DRAWING TITLE:
MECHANICAL SPECIFICATIONS

NO.	REVISIONS	DATE
1	ADDENDUM 1	06/17/2020
2	ADDENDUM 2	07/09/2020
3	PROPOSAL REQUEST 1	07/23/2020
4	ADDENDUM 3	07/28/2020
5	PH #3	08/17/2020

DRAWING TITLE:
LEVEL 03 MECHANICAL PLAN

DRAWING TITLE:
LEVEL 03 REFRIGERANT PLAN

1 LEVEL 03 MECHANICAL PLAN
SCALE: 3/32"=1'-0"

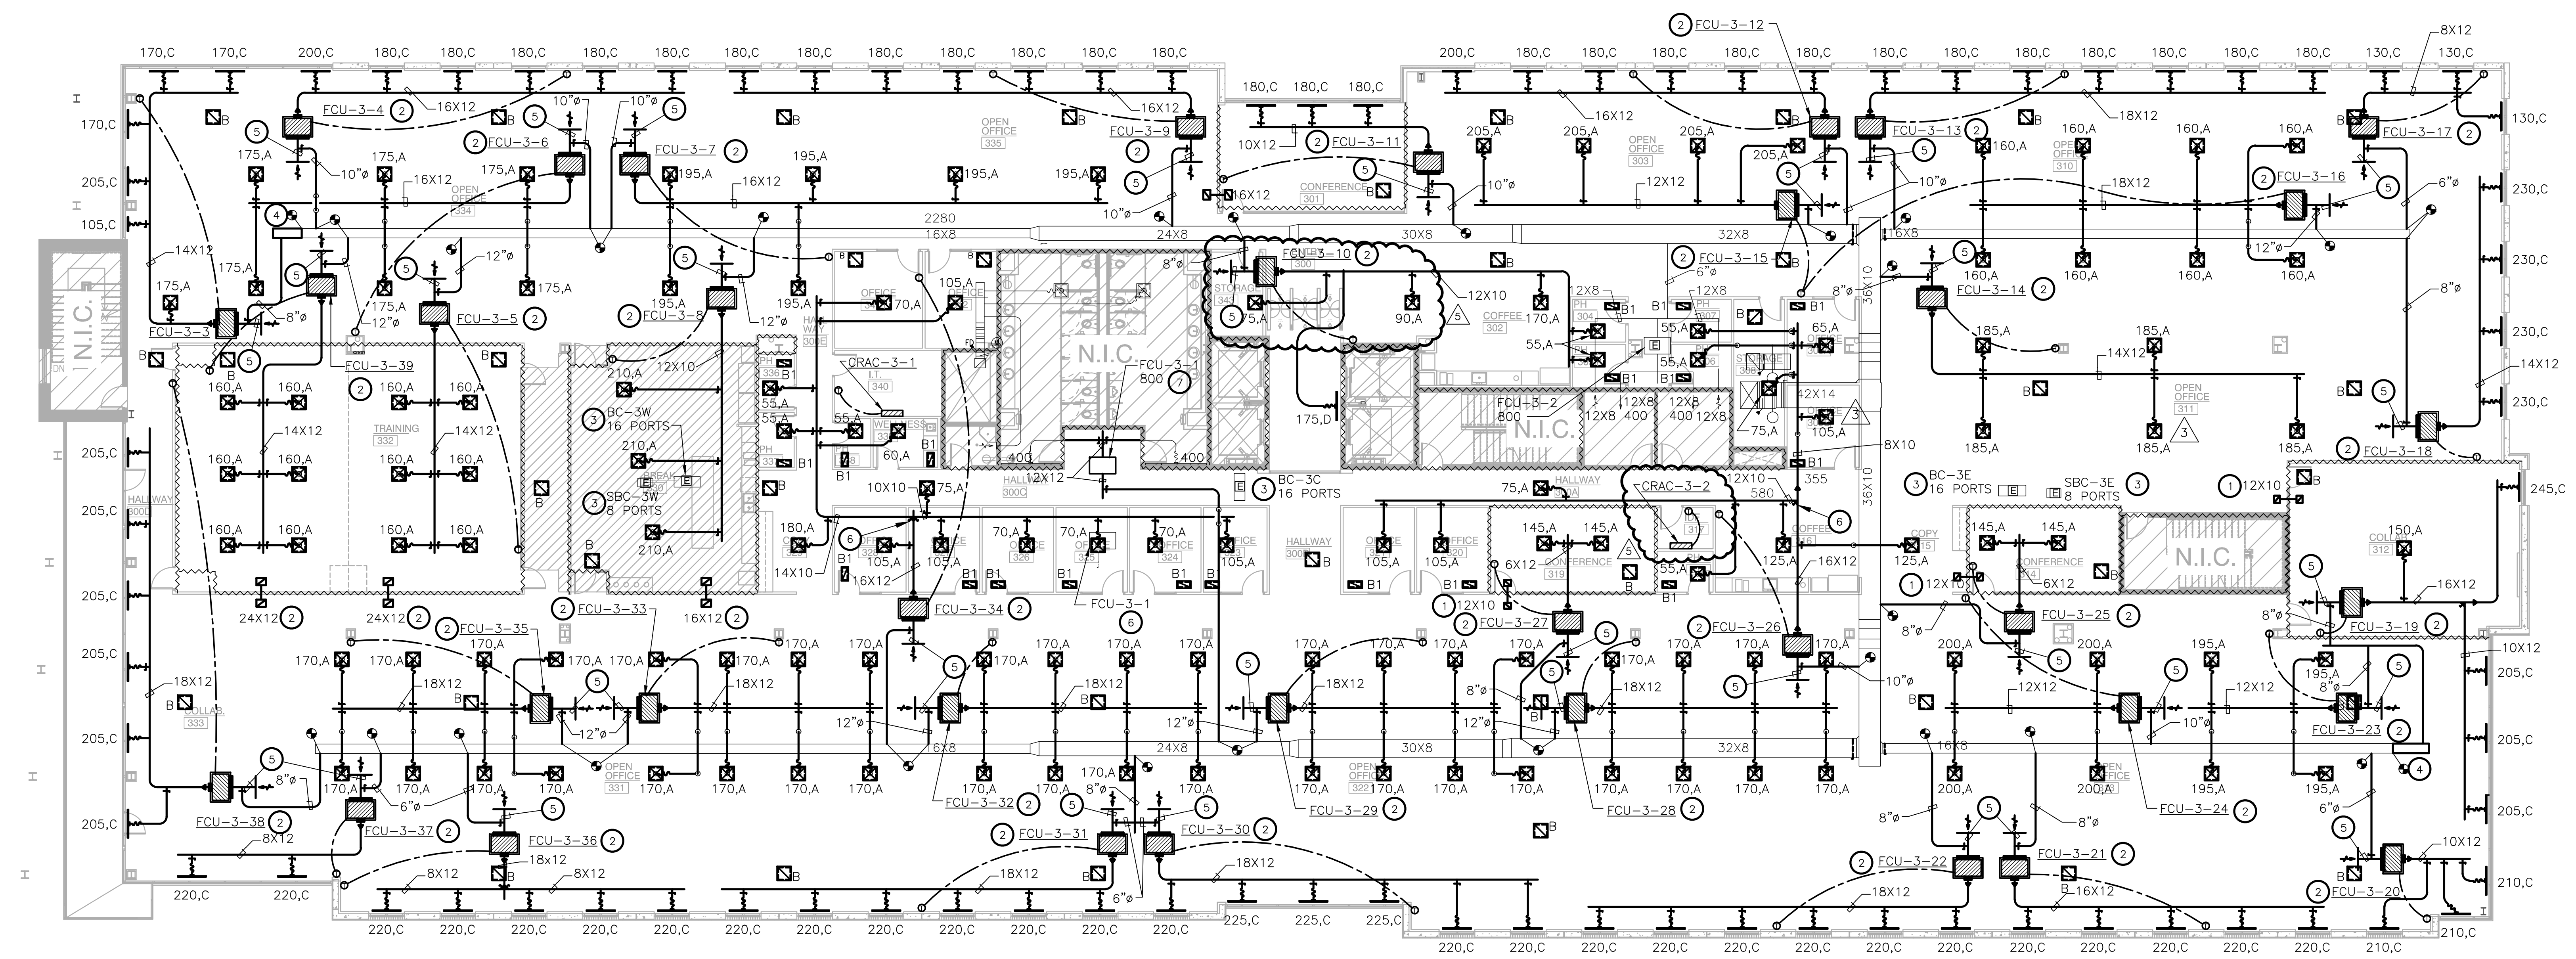
- REVISION SUMMARY:
- RELOCATED SUPPLY GRILLE AND ADDED RETURN AIR GRILLE TO NEW STORAGE ROOM.
 - ADDED CRAC UNIT TO NEW IDF ROOM.

1 LEVEL 03 REFRIGERANT PIPING PLAN
SCALE: 3/32"=1'-0"

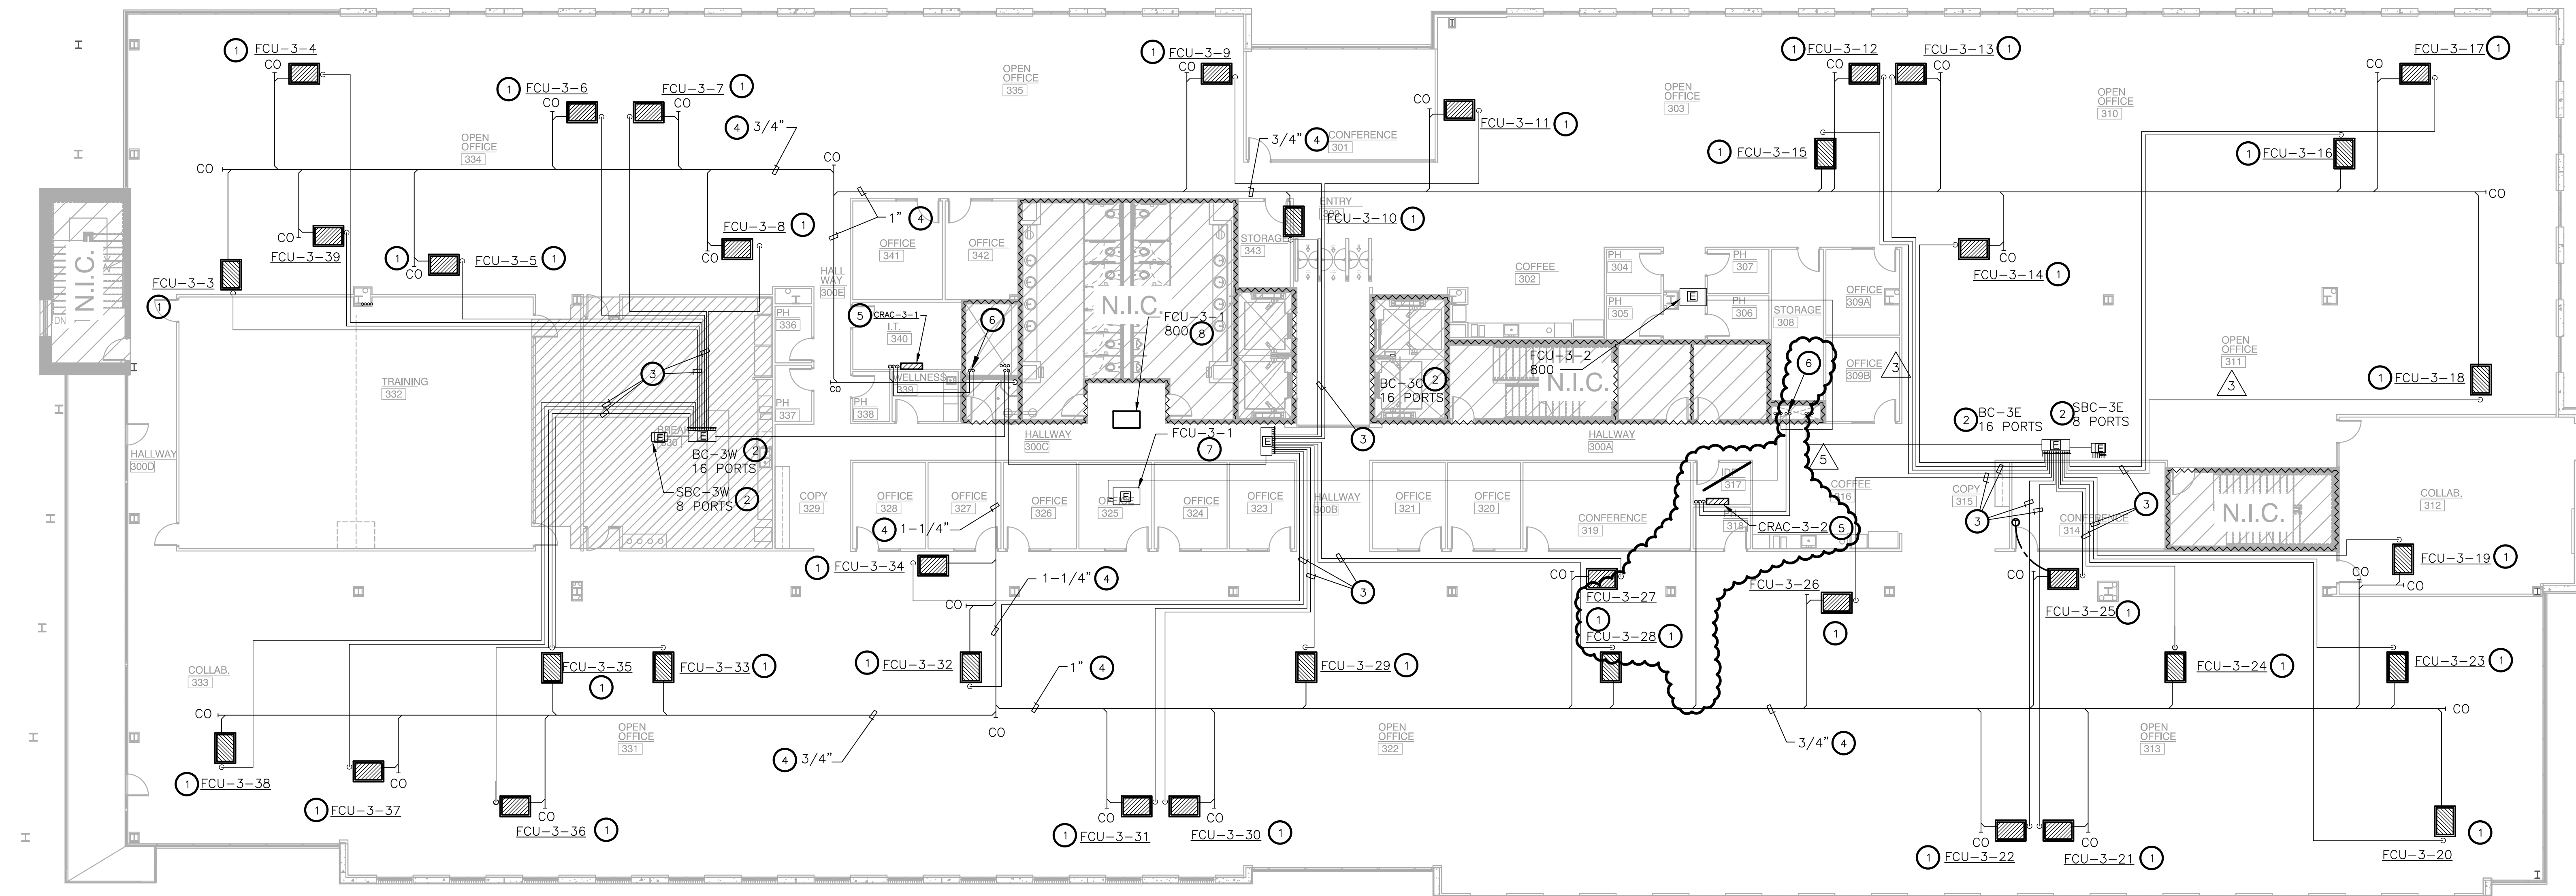
REVISION SUMMARY:
* ADDED CRAC UNIT TO NEW IDF ROOM.
